# **Comments On Background Information For A Proposed Algonquin Provincial Park Management Plan Amendment**

**Submitted on March 3<sup>rd</sup>, 2010  
by the Algonquin Backcountry Recreationalists**

This submission contains specific observations and concerns. It includes both text comments and illustrations which have been extracted from the ABR's "Camp Values Inventory" side-by-side map-comparing utility. Comparisons are drawn between the 2009 Canoe Route Map and the OPB/AFA Joint Proposal High Definition Map. (13 pages)

CVI-SM1-BirchcliffeCreek.jpg

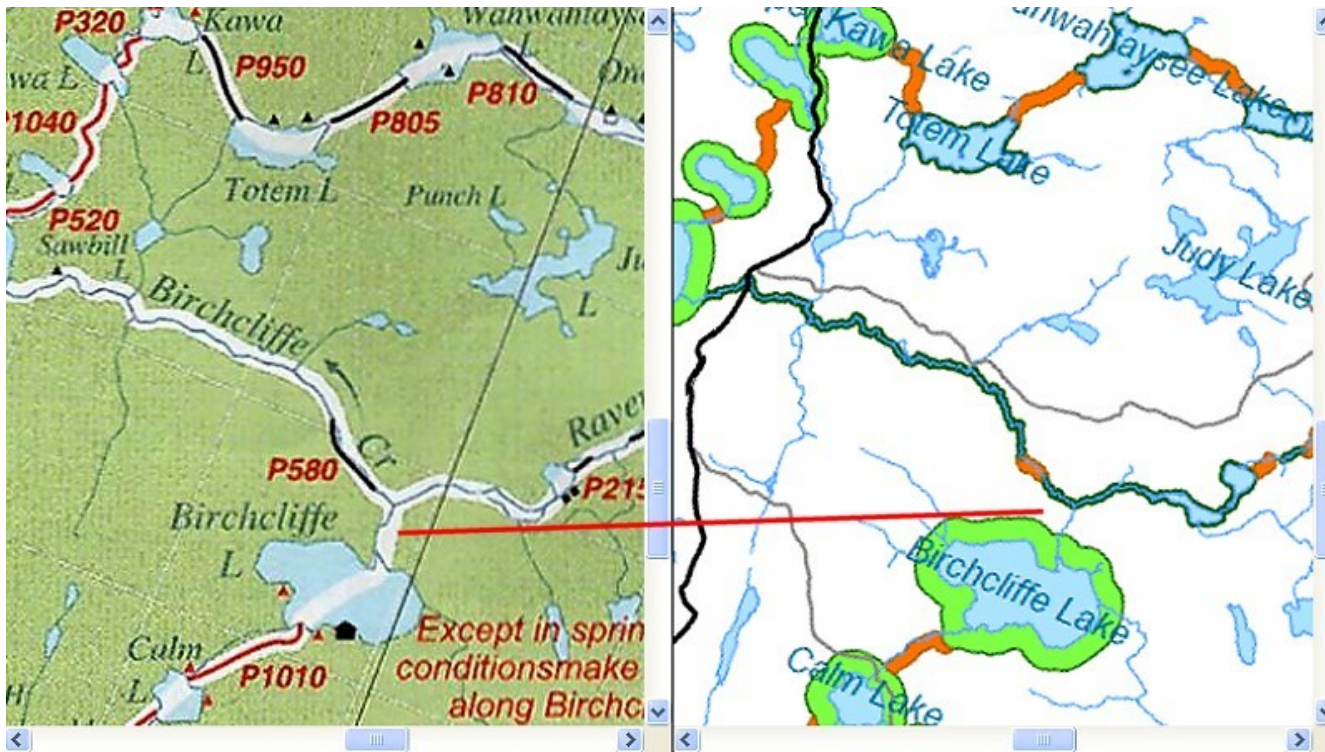
Birchcliffe Creek flows north from Birchcliffe Lake to the main section of Birchcliffe Creek, where Raven Creek joins it.

While all of Birchcliffe Creek is designated as canoe route, this section of the creek isn't portrayed as having any protective zoning.

The ABR believes that a 60 meter protective setback zone should be applied to both sides of this section of the creek.

CVI-SM2-AcanthusLake.jpg

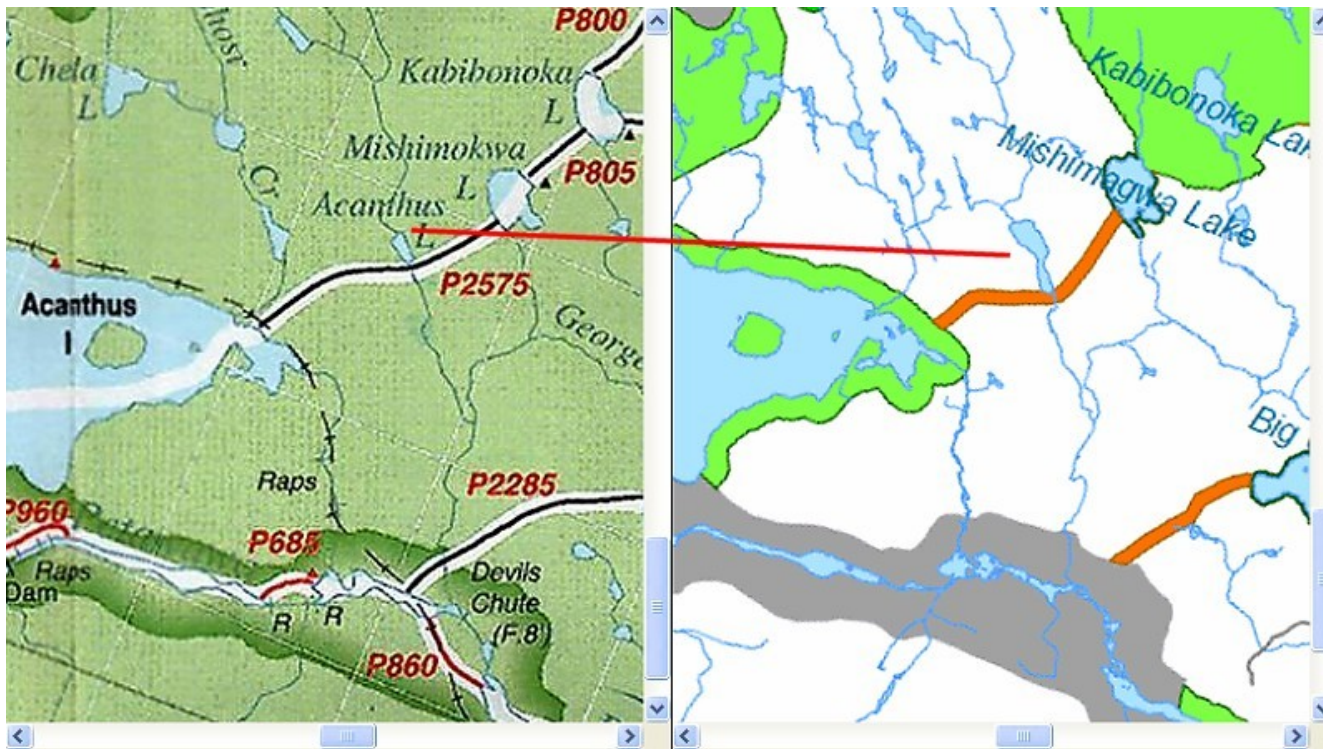
As recently as the summer of 2009, there was a signed portage to Acanthus Lake, branching off from the portage between Cedar Lake and Mishimokwa Lake.

The ABR believes that a 60 meter protective setback zone should be applied around Acanthus Lake.

CVI-SM5-LostCoinLake.jpg

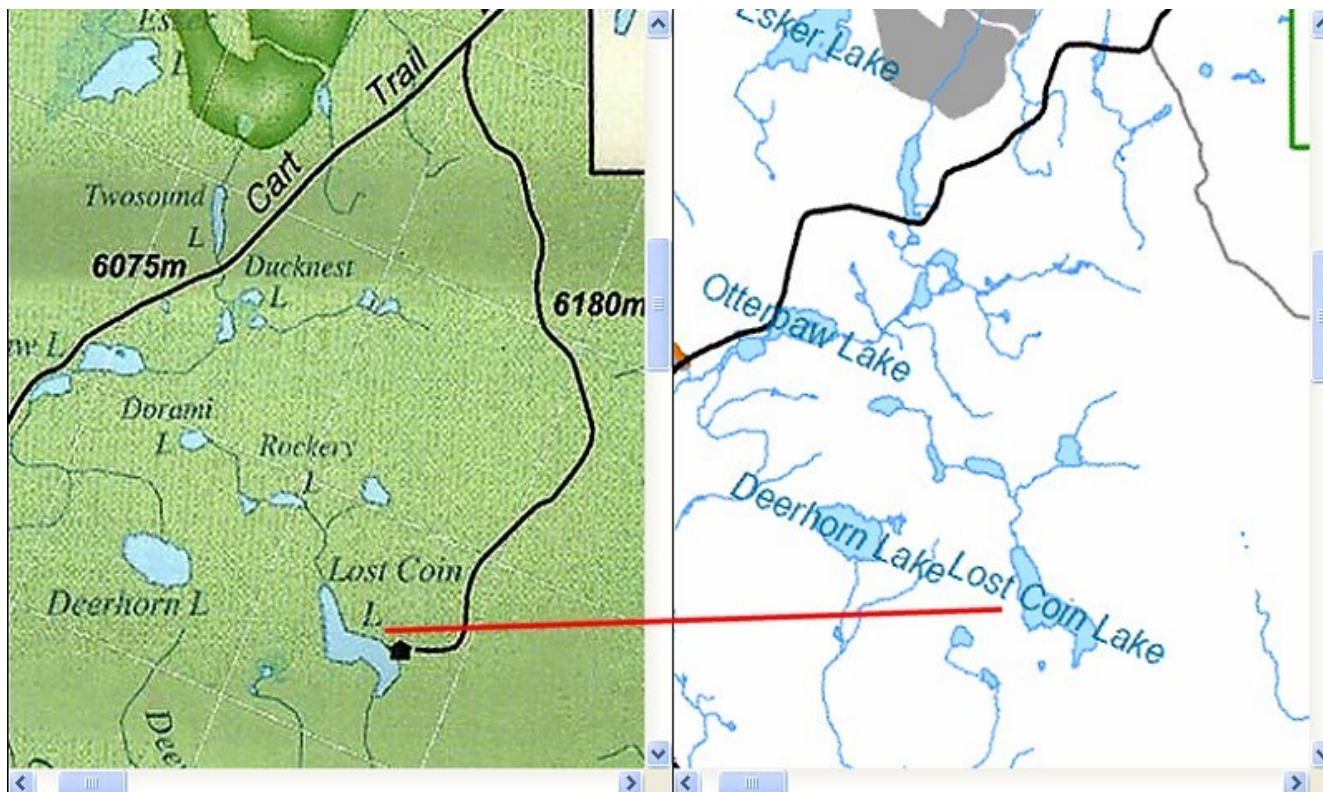
The Lost Coin Lake Cabin is located on Lost Coin Lake. It is accessible from the park boundary by hiking or biking along a 7km trail. The cabin is one of numerous such established backcountry camping values in the park. Activities of people staying there include viewing and exploring the area around the lake.

The ABR believes that a 120 meter protective setback zone should be applied around Lost Coin Lake.

CVI-SM5-PrettyLake.jpg

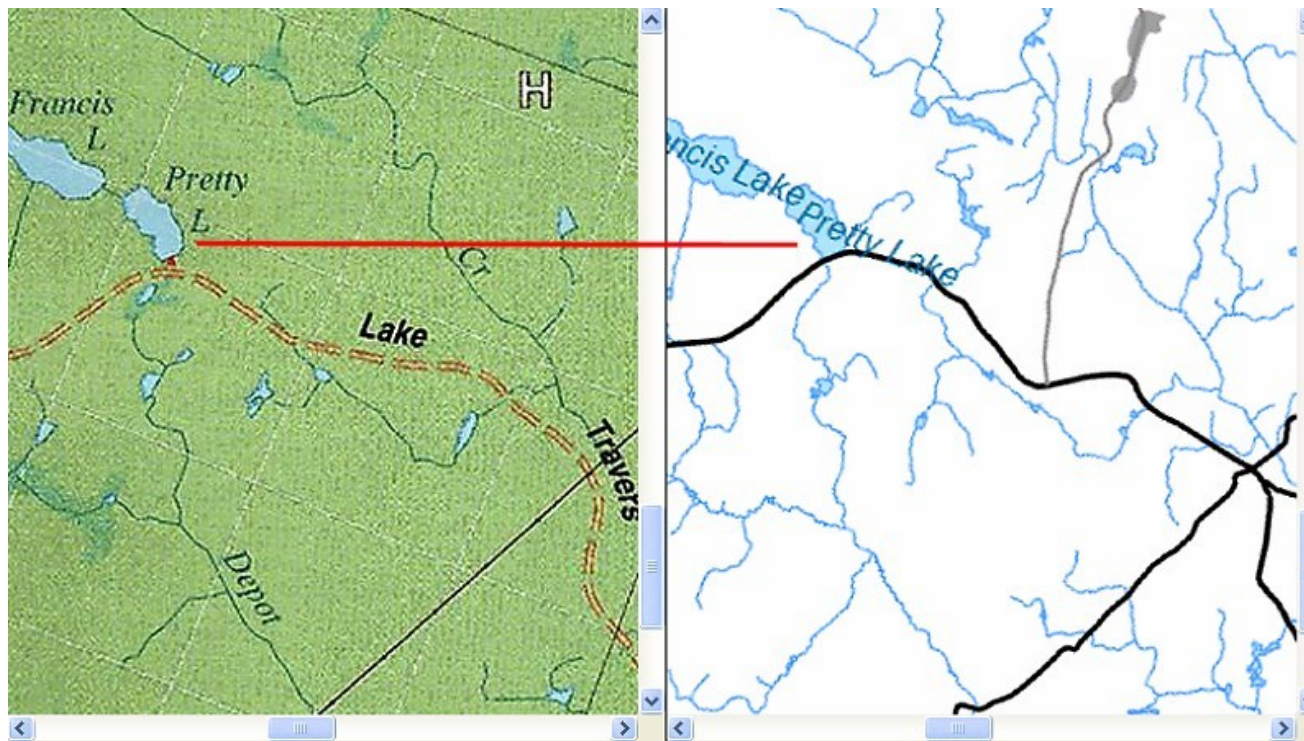
Pretty Lake is located off the Lake Traverse Road and has a single regular maintenance campsite. The campsite and its lake are definitely backcountry camping values. Activities of people staying there include viewing and exploring the area around the lake.

The ABR believes that a 120 meter protective setback zone should be applied around Pretty Lake.

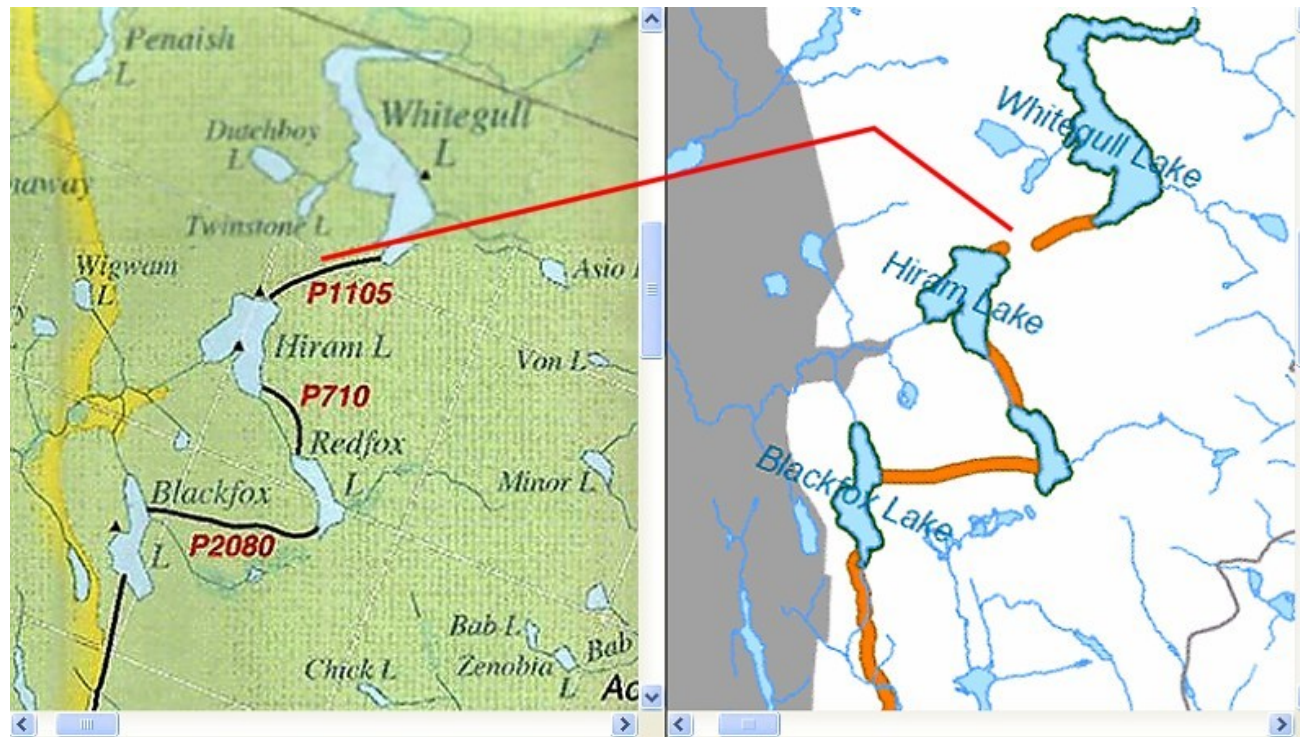
This is an observation rather than a concern, specially given that portages aren't protective zone designations, but rather are Area of Concern designations.

The ABR observes what appears to be a “gap” in the portage between Hiram Lake and Whitegull Lake.

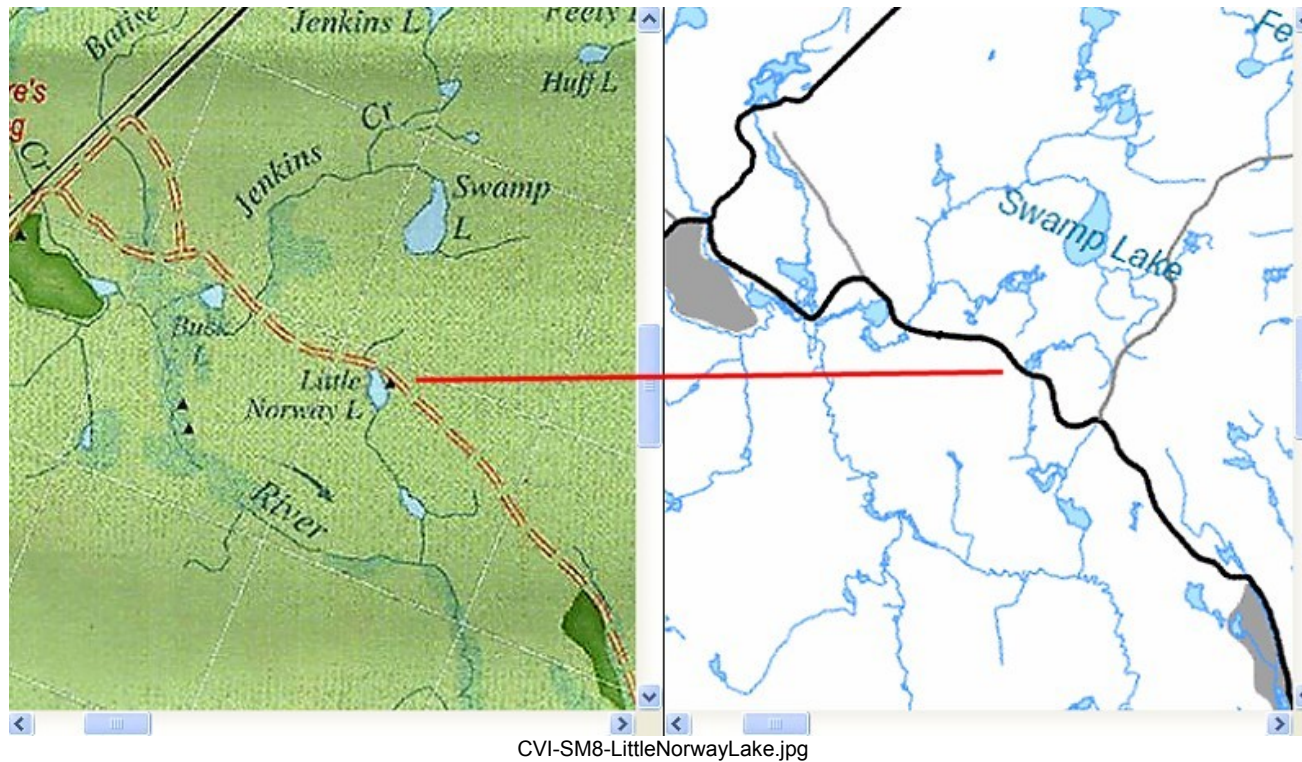
Little Norway Lake is located off the Basin Lake Road south of the Hydro Line and has a single low maintenance campsite. The campsite and its lake are considered backcountry camping values. Activities of people staying there include viewing and exploring the area around the lake.

The ABR believes that a 60 meter protective setback zone should be applied around Little Norway Lake.

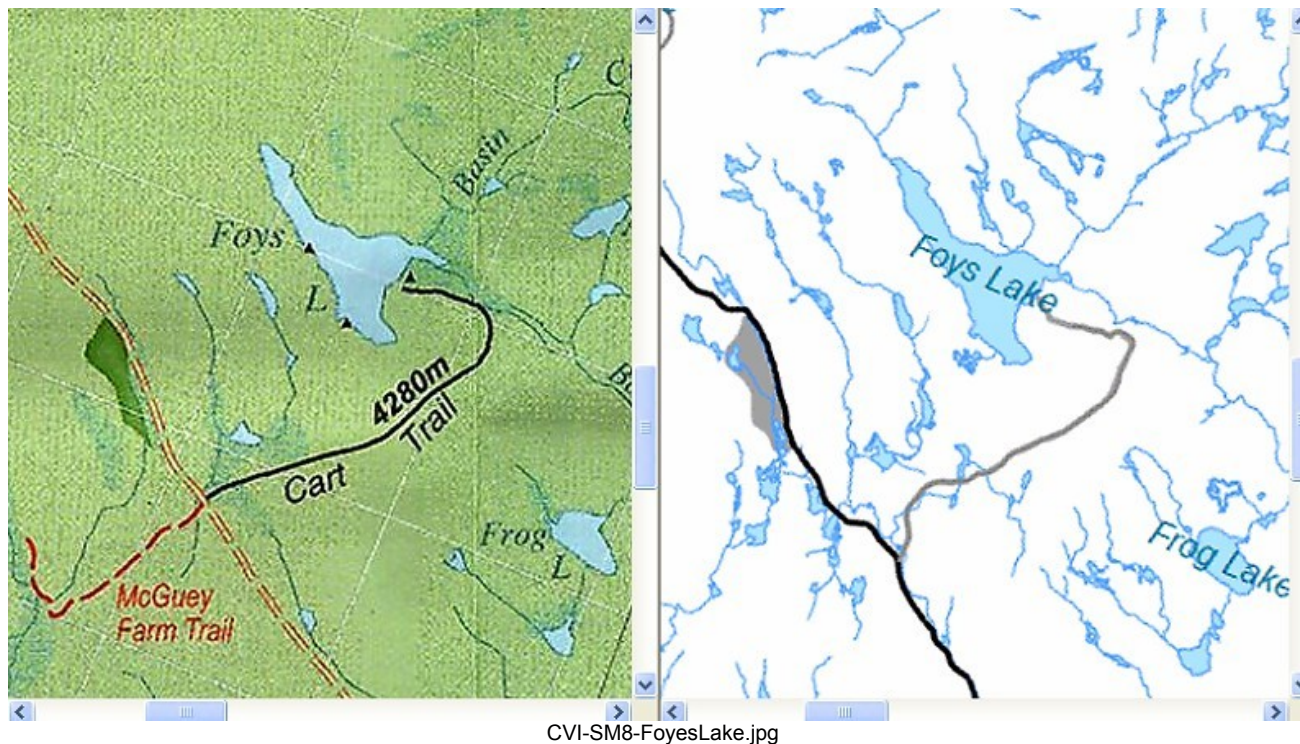
Foys Lake is located at the end of a 4280 meter cart trail off the Basin Lake Road and has three low maintenance campsites. Two of those campsites can only be reached by canoe. These campsites and their lake are considered backcountry camping values. Activities of people staying there include viewing and exploring the area around the lake.

The ABR believes that a 60 meter protective setback zone should be applied around Foyes Lake.

CVI-SM8-MarmotLake.jpg

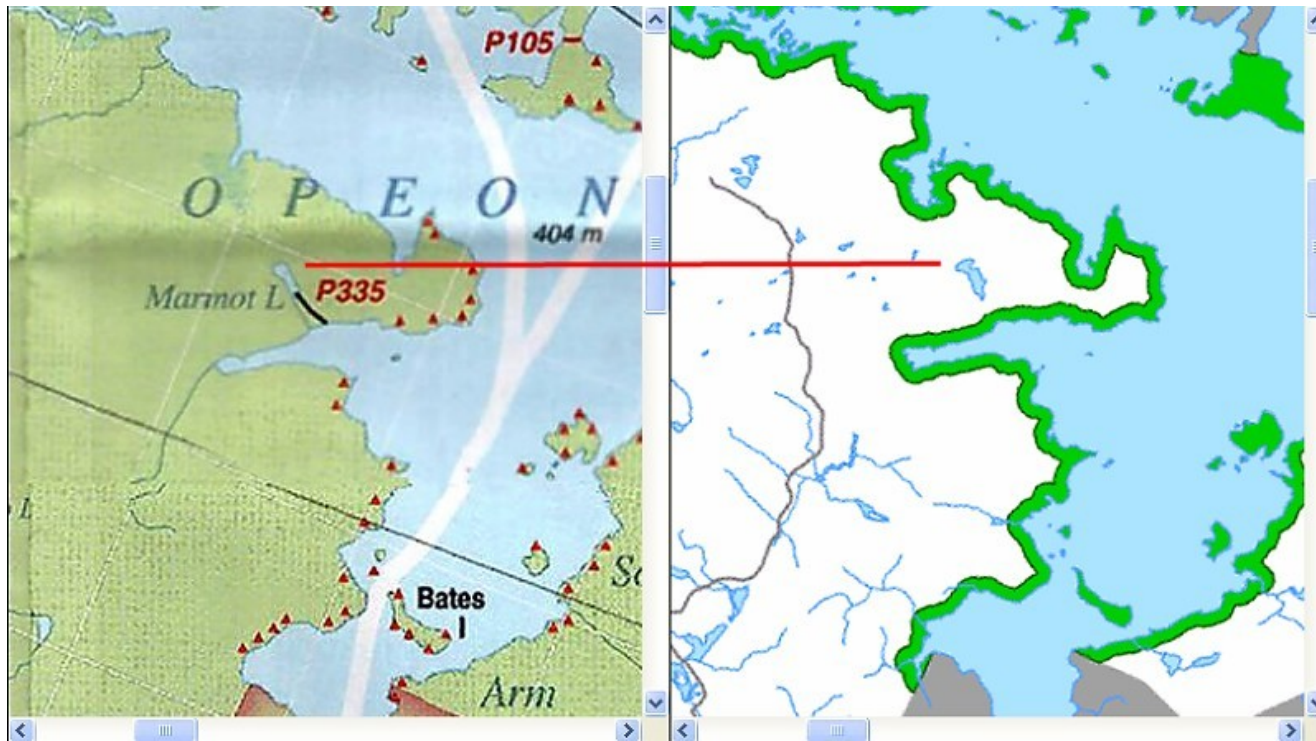
On the west shore of Lake Opeongo, there is a 335 meter portage to Marmot Lake.

The ABR believes that a 60 meter protective setback zone should be applied around Marmot Lake.

CVI-SM6-FurrowLake.jpg

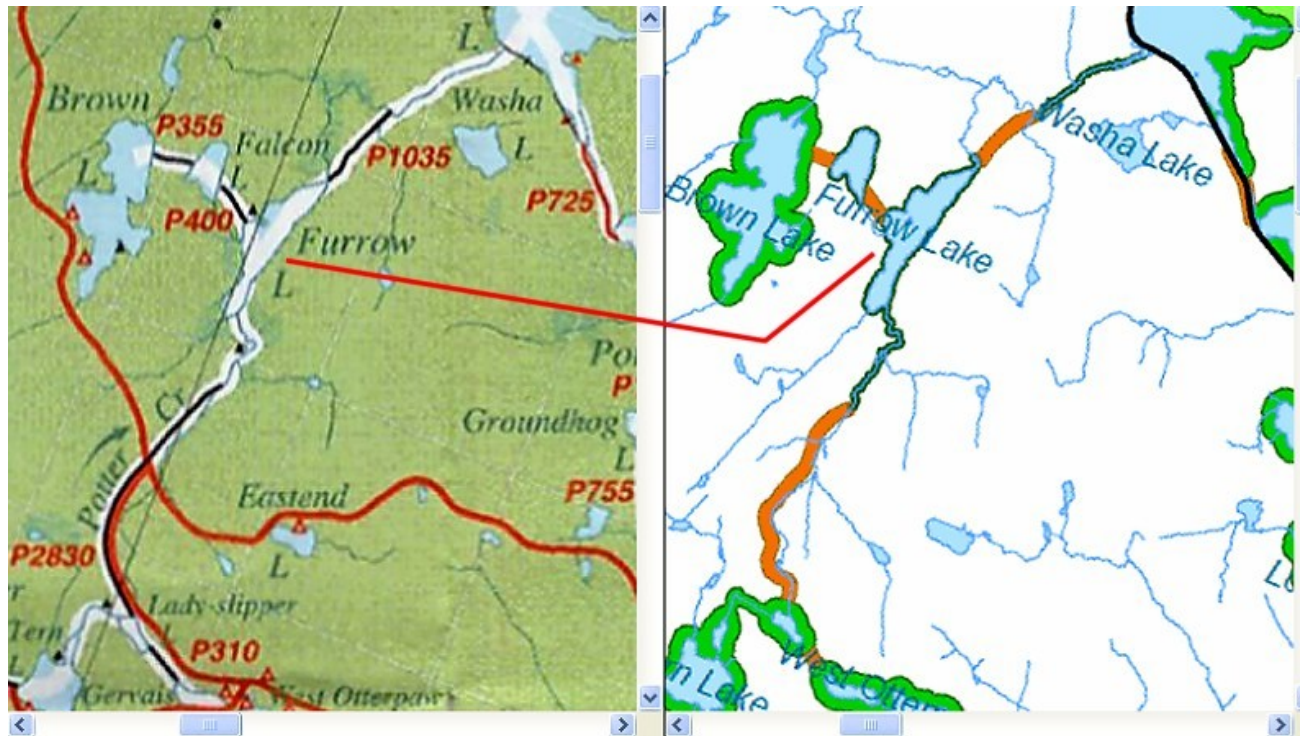
Furrow Lake, Falcon Lake and two parts of Potter Creek are located centrally amidst Brown Lake, Lady Slipper Lake and Brule Lake, which all have 120 meter protective setback zones. However, despite having a pair of campsites and being on a common canoe route with the previously mentioned lakes, they only have 30 meter protective setback zones.

The ABR believes that Furrow Lake, Falcon Lake and the two connected parts of Potter Creek should also have 120 meter protective setback zones, in order to maintain aesthetic continuity and consistency.

CVI-SM6-UplandsTrail.jpg

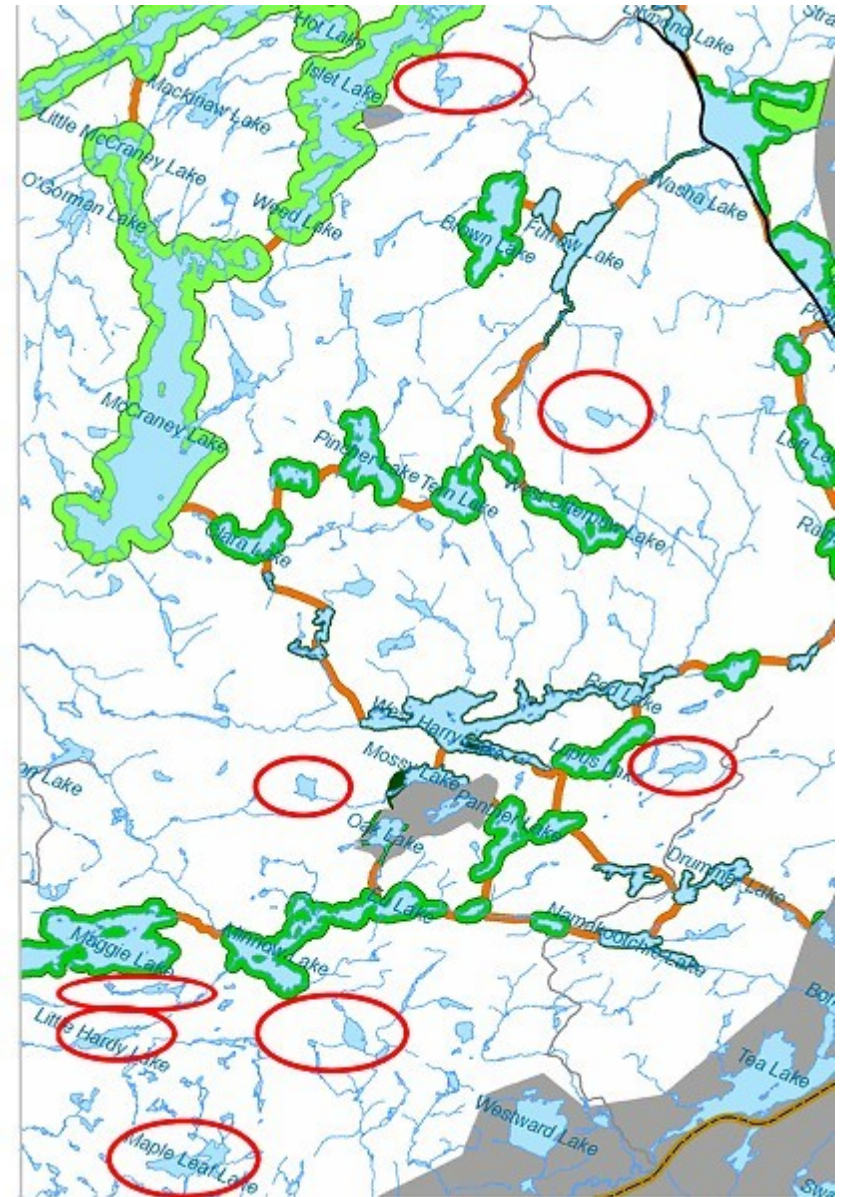
Those lakes on the Western Uplands Backpacking Trail which have hiking campsites, but no canoe-route campsites, haven't been provided with any protective setback zones.

Activities of people camping on these lakes include both viewing and exploring the areas around the lakes.

The ABR believes that, in order to maintain consistent wilderness-like aesthetics, all the Western Uplands Backpacking Trail campsite lakes warrant 120 meter protective setback zones.
